**Notice of Meeting for the
Historic and Architectural Review Commission
of the City of Georgetown
April 9, 2020 at 6:00 PM
at**

- D **Public Hearing** and **possible action** on a request for a **Certificate of Appropriateness** for an addition that creates a new, or adds to an existing street facing façade at the property located at 701 University Avenue, bearing the legal description of 0.31 acres out of the southwest portion of Block 2, Snyder Addition. – Britin Bostick, Downtown & Historic Planner

- E **Public Hearing** and **Possible Action** on a request for a **Certificate of Appropriateness** for a 19.3’ setback encroachment into the 25’ required garage (west) setback, a 6’ setback encroachment into the required 6’ side (north) setback, and a 3’ building height increase from the required 15’ maximum building height at the side (north) setback line allowing for a building height of 18’ at the side setback at the property located at 403 E. 4th Street, bearing the legal description of 0.472 acres out of Block 24, OUTLOT DIVISION C. – Britin Bostick, Downtown & Historic Planner

- F **Public Hearing** and **Possible Action** on a request for a **Certificate of Appropriatenes

This is the rectangular structure that would be allowed with the setback encroachments requested in the 2020 proposal

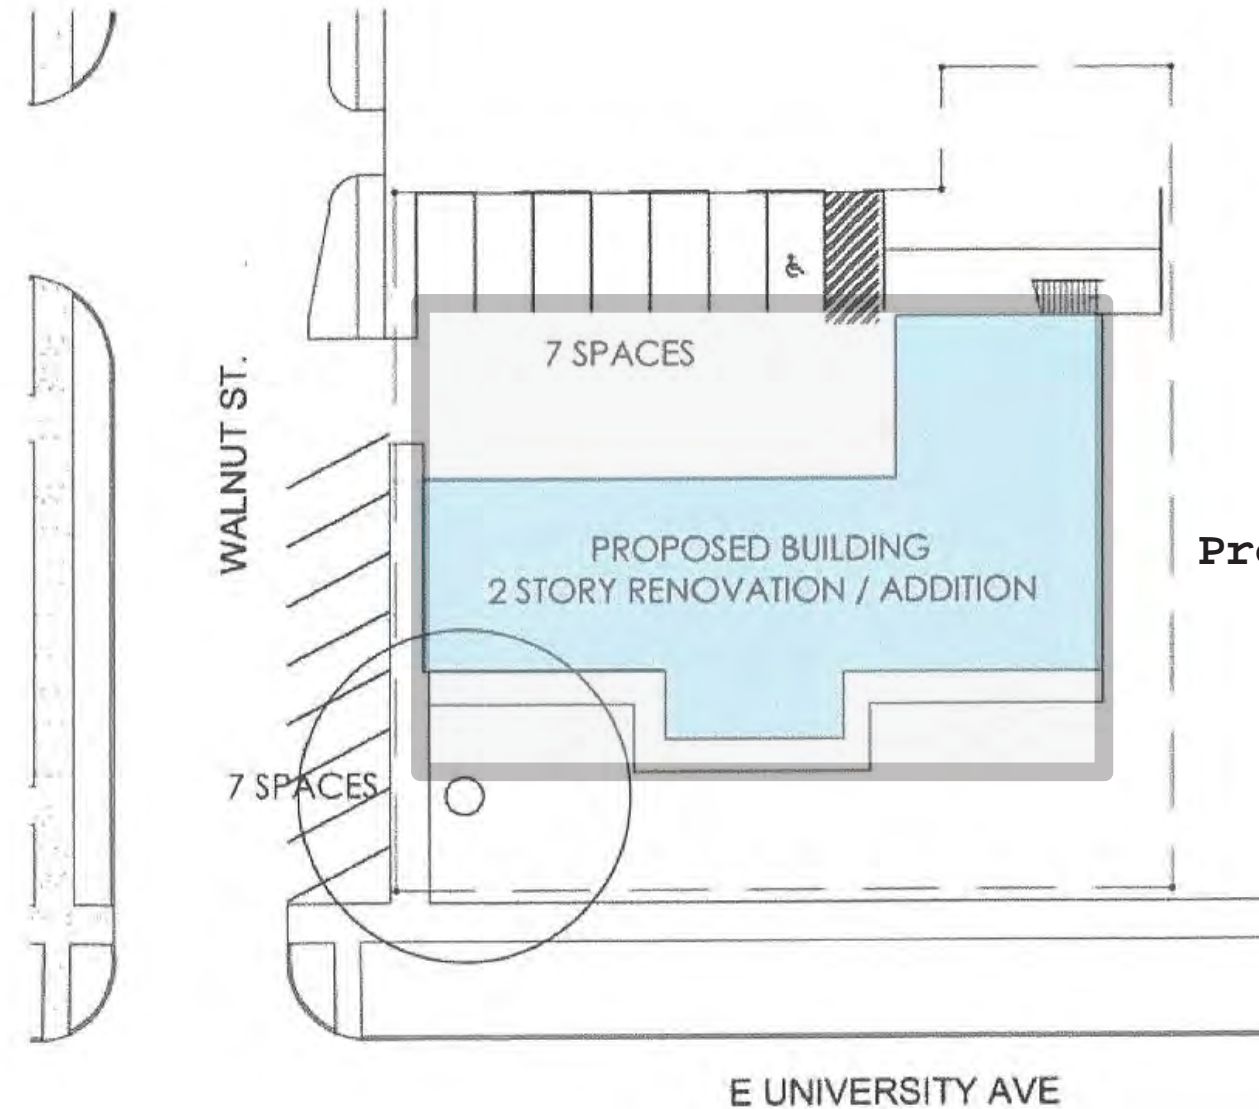
I am writing to state my unequivocal opposition to the plans for "developing" the subject property. The current plans would violate several longstanding rules for commercial property development. More importantly, the plan would create an unreasonable condition for the adjoining neighborhood. This neighborhood deserves to be considered as important criteria for making any decision regarding this property. I also believe that the proposal would cause many issues for the the 29 highway. While I could delineate all he reasons why the proposal should not be approved, I also believe that the city planning department has to be aware of the inherent fallacies in this proposal. However, I would be more than pleased to speak to this in any forum where this opportunity would be provided.

If the requested encroachment are allowed without more detail the proposed structure could be rectangular in size and fill most of the parcel.

701 University Ave. – Prior Approved Elevations

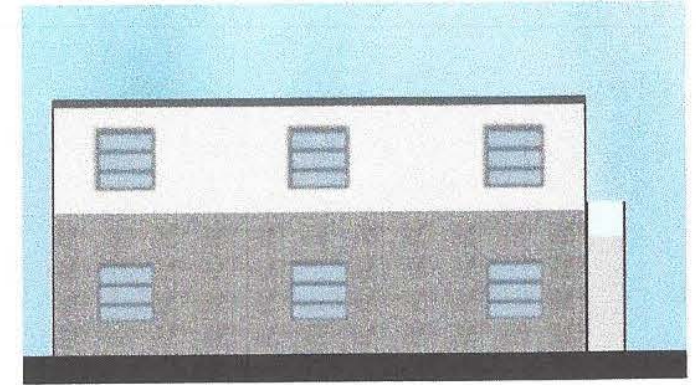
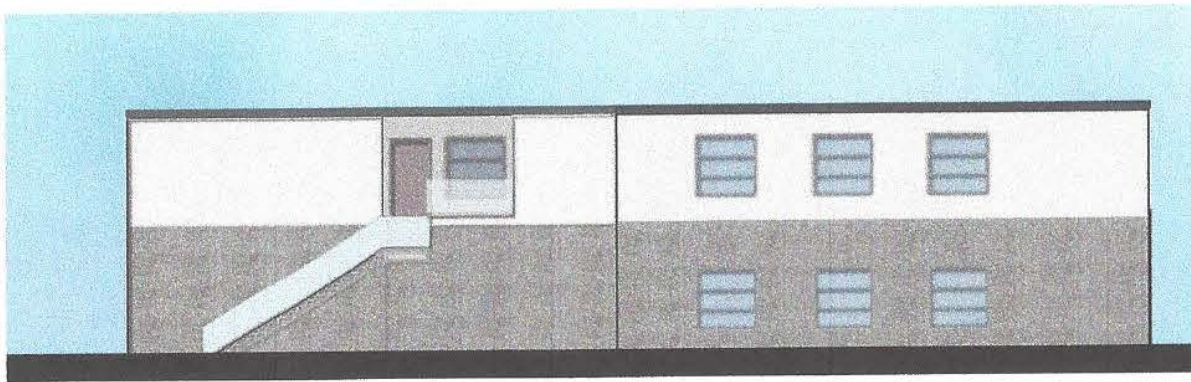
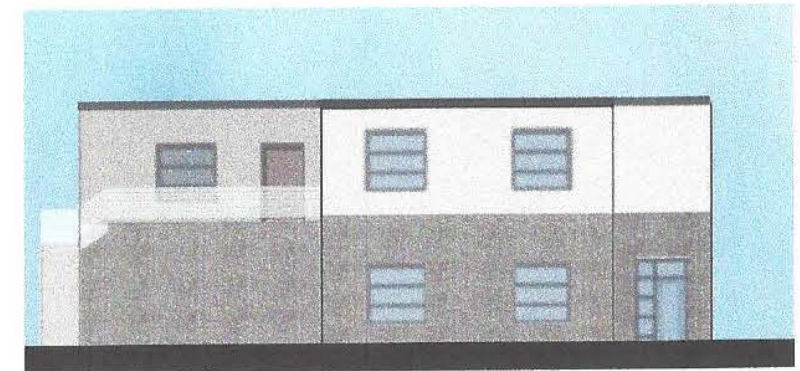
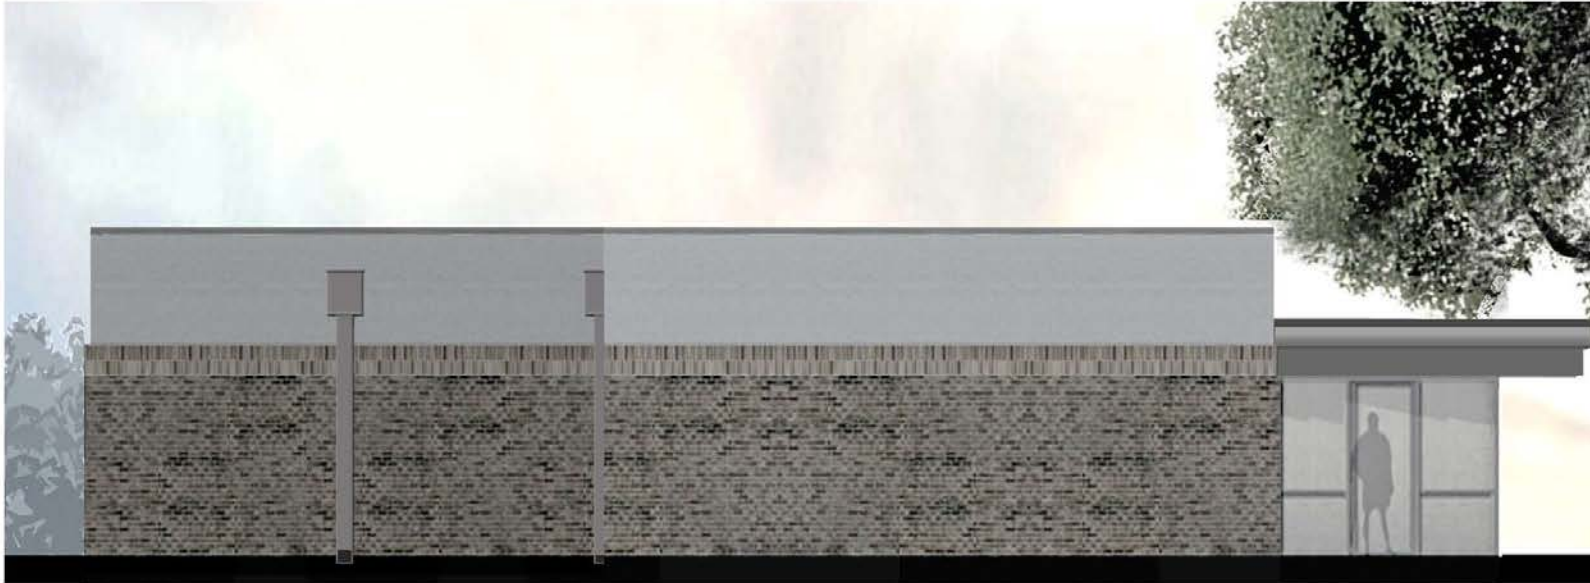
In the revised design, the applicant is proposing to add 5’-0” to the height of the existing brick building, which will retain the flat roof construction of the original structure and allow for the installation of modern HVAC (heating, ventilation and air conditioning) equipment above the ceiling, as well as to raise the ceiling in the interior spaces. Per the applicant’s Letter of Intent dated February 18, 2020, the original height of the brick building was 9’-10” and the proposed new height with the addition of stucco-clad wall sections above the existing brick walls is 14’-10”. As this height includes a 1’-0” roof parapet, the proposed building height is 13’-10” per the UDC definition, which is within the height requirements for the Old Town Historic Overlay District. Also included in the revised design are a new configuration of the windows in the covered main entrance (a change from the original large pane windows to multi-pane storefront windows with the entrance door moved to the far left or westmost window section); the installation of new windows in the original brick walls on the front (south) and side (east) facades; and the removal of the rear “ribbon windows” and replacement with brick and fewer windows to match the new windows on the front (south) façade. Lastly, the proposed exterior alterations include removal and addition of doors to accommodate the reconfiguration of the interior, as well as the addition of small metal awnings over the doors.

The design is simple. We are keeping the existing brick and adding a double soldier course on top of the brick. Then we are using stucco above the brick line. This is almost identical to the previously approved design but the new design will emphasize the scalloped roof by keeping the elevation change behind the scallop roof structure as opposed to cantilevering over it as previously approved.

There are no other changes to the previously approved plan other than eliminating a store front on the south west corner. This again is keeping with the original design of this mid-century building.

701 University Ave. – Proposed Elevation

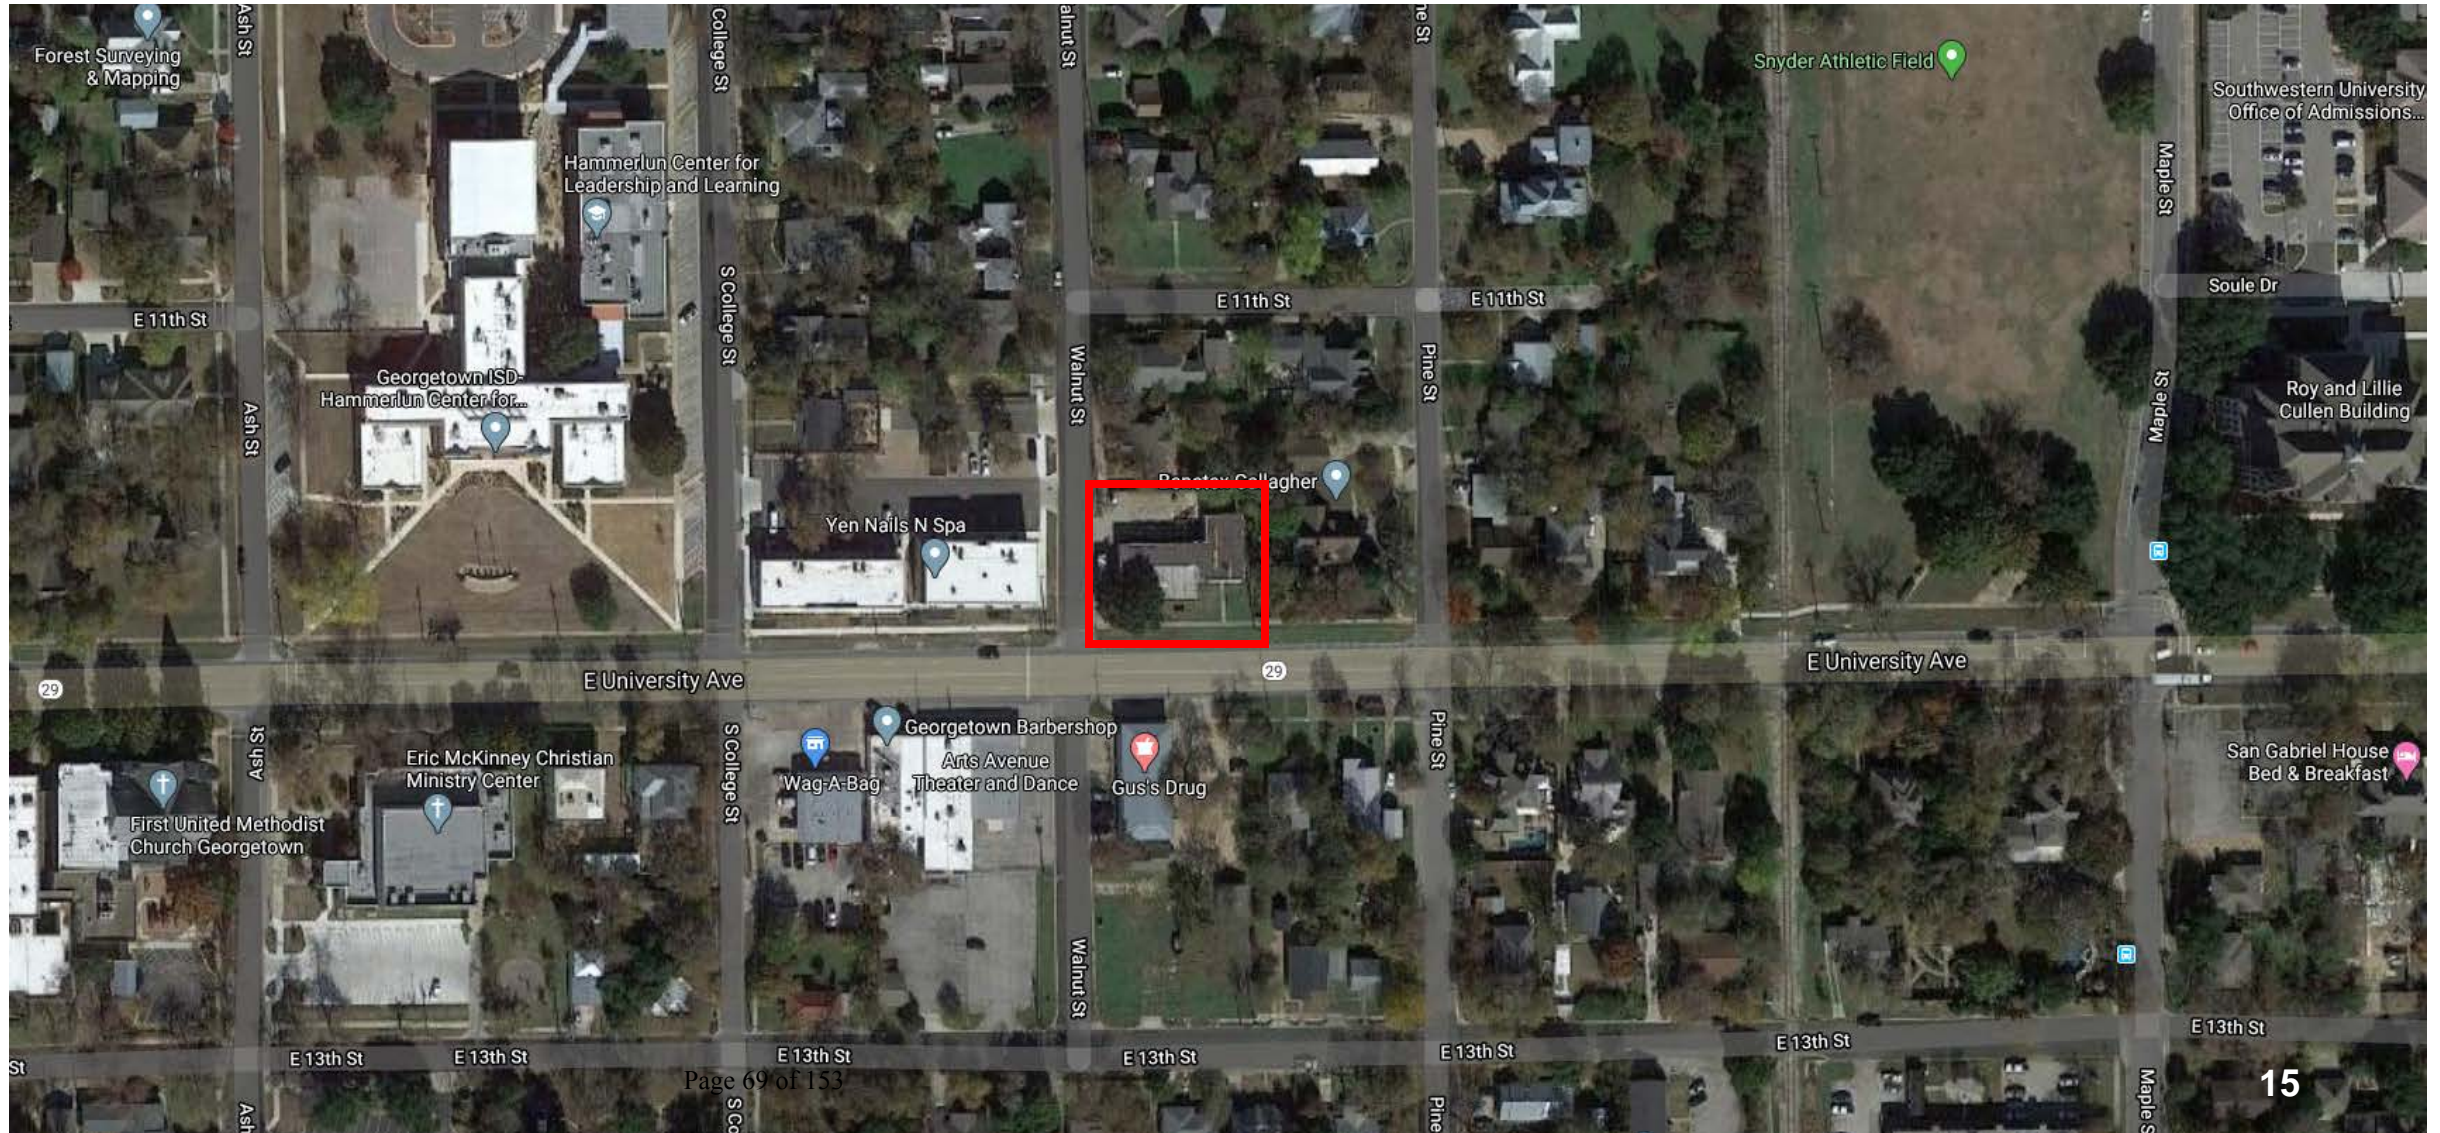
Applicant has already gutted the building. His previous approvals from
HARC (2016) should not be modified to extend the building facade.

Based on the findings listed above, staff recommends *APPROVAL* of the request for the reasons stated above. Additionally, HARC approved the increase in height and a second-floor addition as well as alterations to the windows and the installation of new windows in 2016, and the revised design presented in this application is a considerable improvement over the previously approved design in terms of scale of the finished building, alteration of the exterior and the amount of stucco relative to the existing brick. The proposed increase in height is not out of scale with the current structure or surrounding structures, and key architectural features at the primary entrance will still be retained. Staff would like to further note that the COA review requirement in the UDC is specific to the street-facing facades, which are the two facades least altered from the original design and most improved by the proposed design revisions.
